Informal document N° 4
(33rd GRSP, 2-6 June 2003
agenda item B.1.3)

AMENDMENTS TO UN/ECE R17 – STRENGTH OF SEATS

OICA COMMENTS TO THE PROPOSAL BY THE CZECH REPUBLIC: TRANS/WP29/GRSP/2003/3

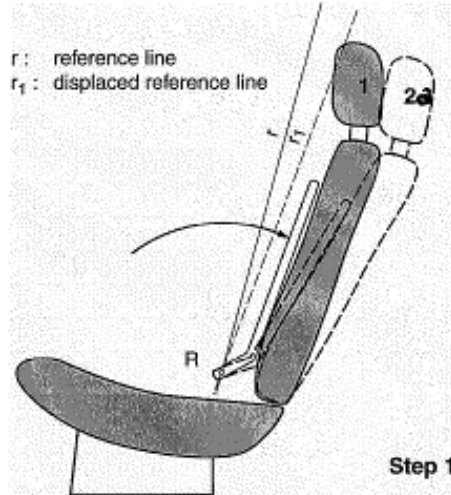
OICA welcomes the proposal by the Czech Republic to better define the figure of annex 5 to the Regulation.

However, OICA, after careful consideration, believes that the Czech proposal needs correction in order to reflect the text of the Regulation and test practice.

Indeed, paragraph 6.4.3 of R17 in effect foresees four positions:

- Position 1: Original unloaded position.
- Position 2a: Displaced position by applying to the manikin's back a moment of 373 Nm around the R point; the displaced reference line r_1 is determined in this position 2a (paragraph 6.4.3.2).
- Position 2b: Displaced position by applying to the 165 mm sphere a force F producing a moment of 373 Nm about the R point, keeping the displaced reference line r_1 in place (paragraph 6.4.3.3). The tangent Y and the displacement X (limited to 102 mm – see paragraph 5.11) are determined in this position 2b (paragraphs 6.4.3.4 and 6.4.3.5).
- Position 3: Final position after the force F has been increased to 890 N in accordance with paragraph 6.4.3.6. As indicated in paragraph 5.12, the head restraint and its anchorage must withstand this force without breakage.

Consequently, OICA proposes to revise TRANS/WP29/GRSP/2003/3 as follows:

“Annex 5, the figure, amend to read:

1. Original unloaded position
- 2a. Displaced position by a moment of 373 Nm of manikins's back in relation to R point
- 2b. Position after displacement by an initial force F producing a moment of 373 Nm about R point
3. Position after displacement by the force F increased to 890 Nm
